Hillcamp Trail – Referral #2 Public Comments - Response Letter

SB25-0014 – Hillcamp Trail Plat and Construction Plans

This letter responds to comments provided regarding Application SB25-0014 for the Hillcamp Trail Plat and Construction Plans. Responses to comments regarding the other two applications (SB25-0009 and SB25-0010) will be provided with the resubmittal of those applications.

BRIDGE OWNERSHIP AND MAINTENANCE EXHIBIT

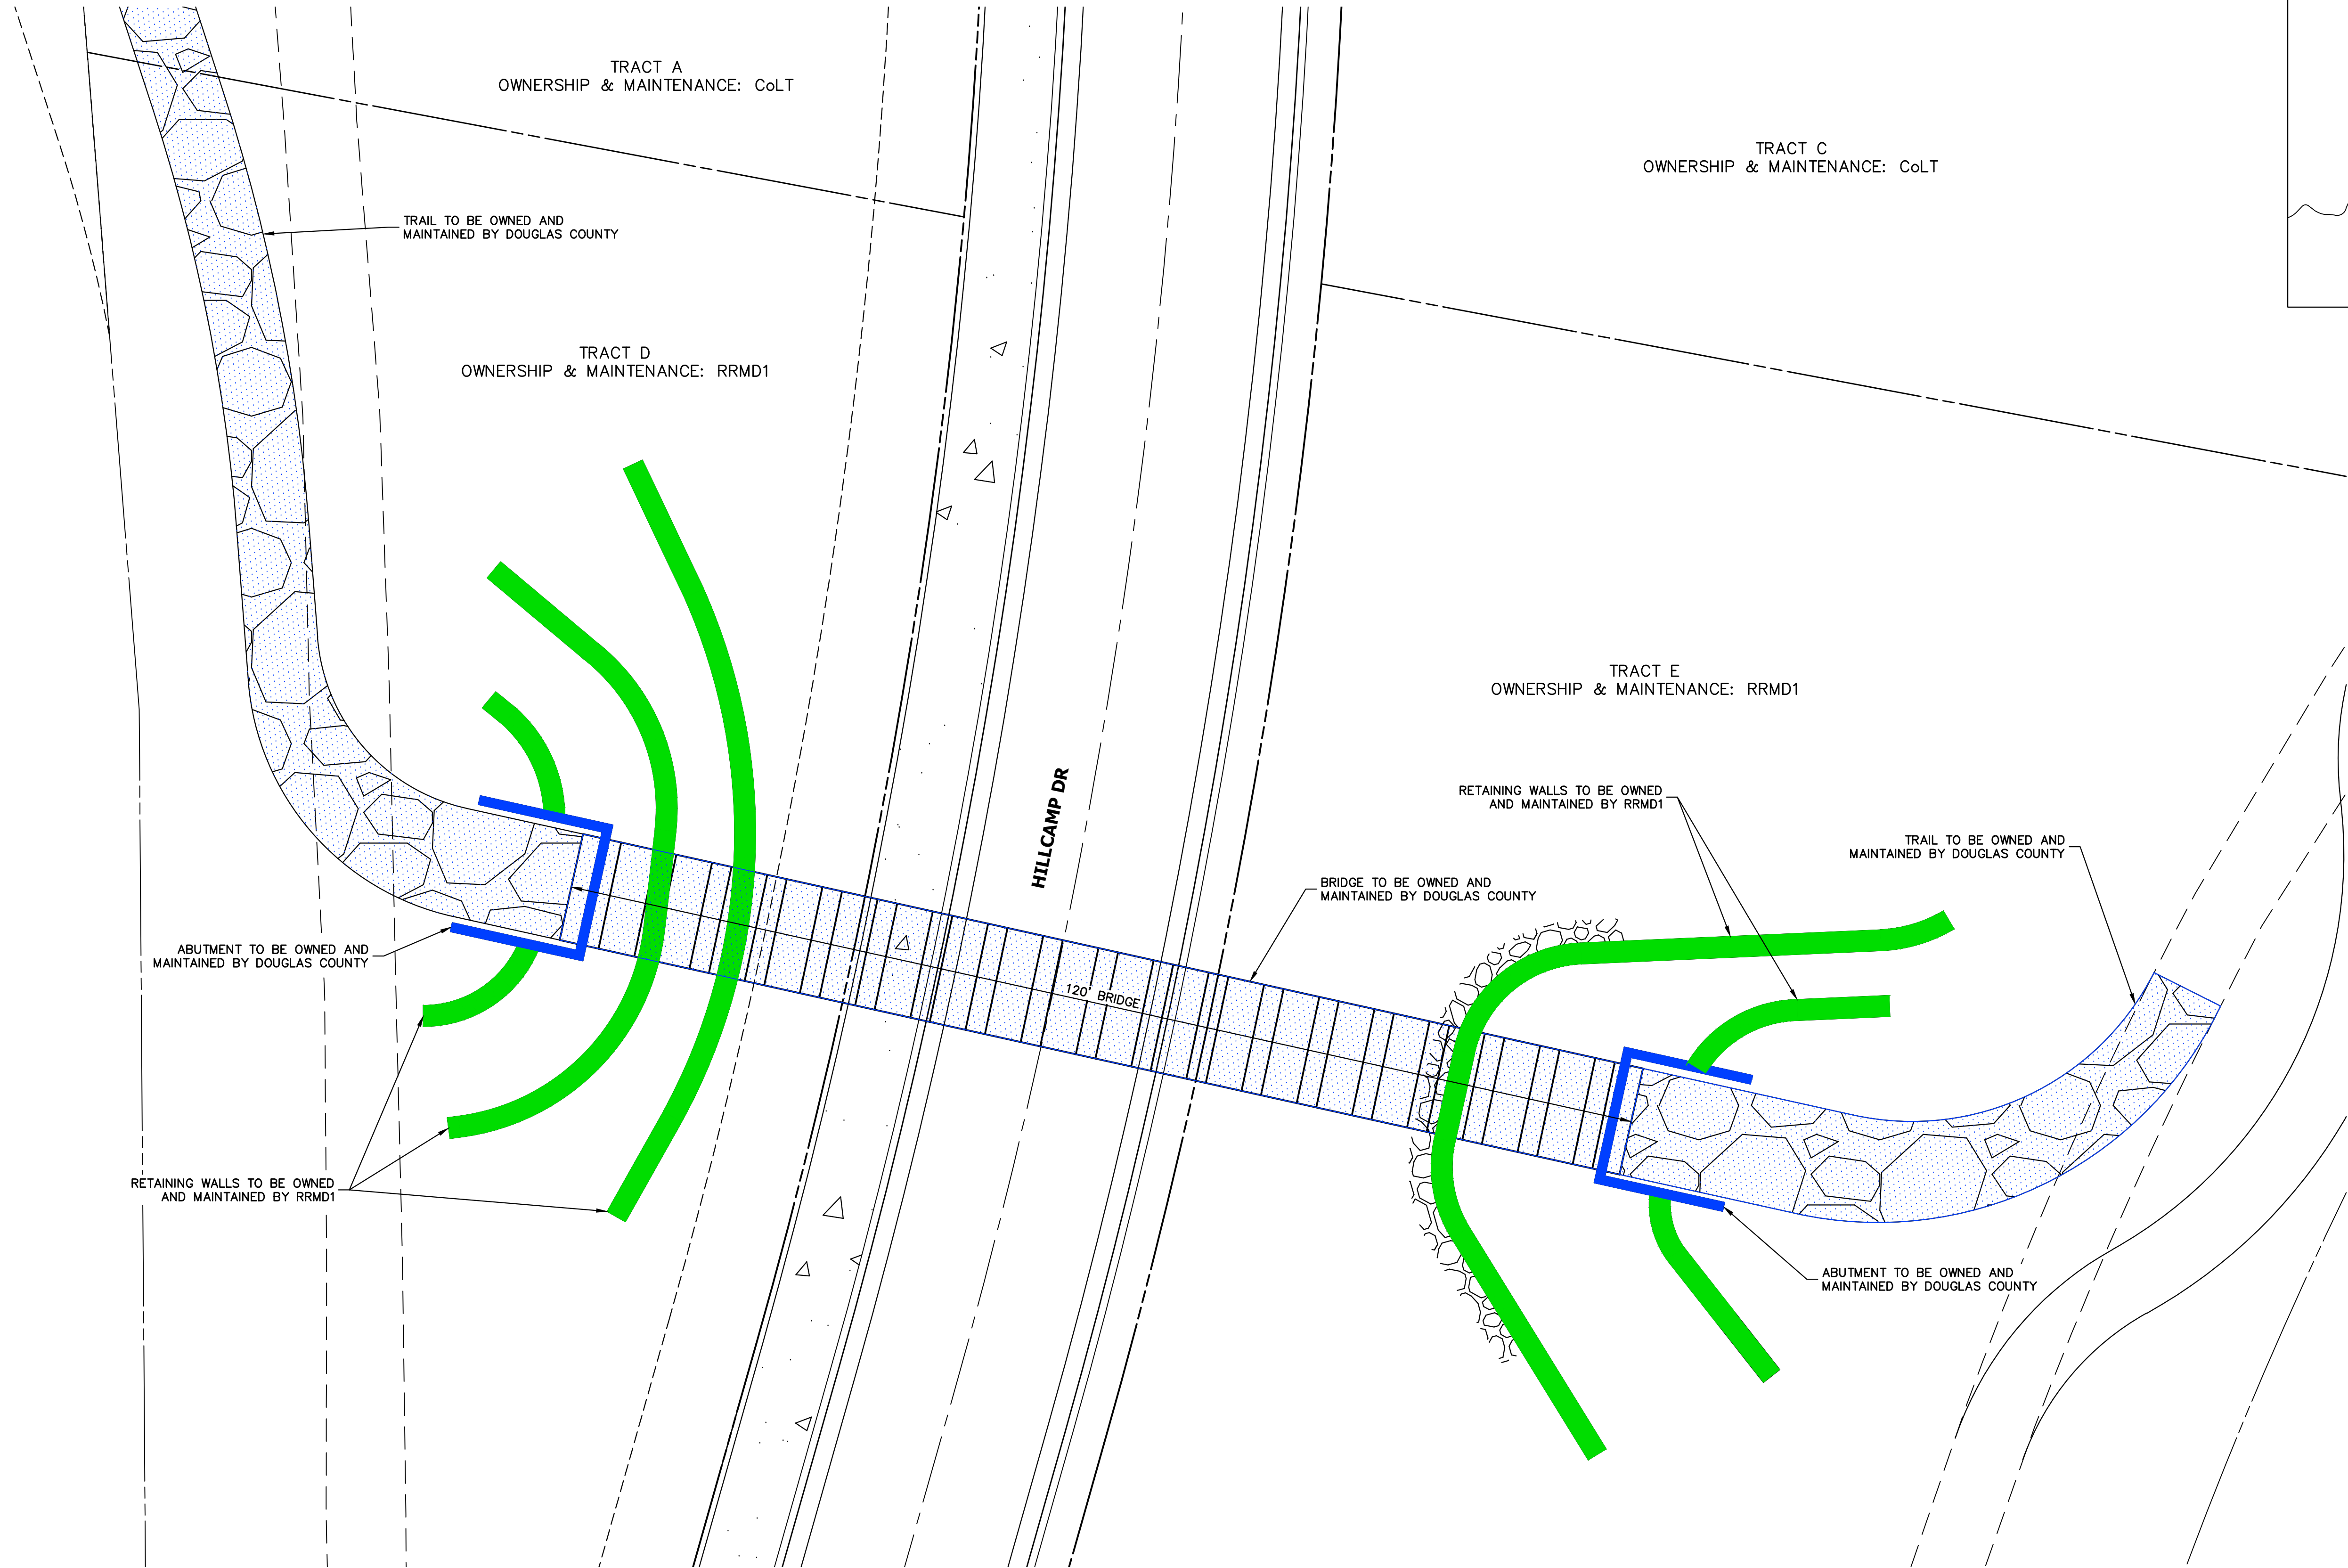
The intent of this letter is to clarify ownership and maintenance responsibilities of the proposed pedestrian bridge associated with the development of Hillcamp Trail. Upon approval and recordation of the final plat, Douglas County has agreed to own and maintain the pedestrian bridge and bridge abutments, and Rampart Range Metropolitan District No.1 will own and maintain the associated retaining walls supporting the pedestrian bridge.
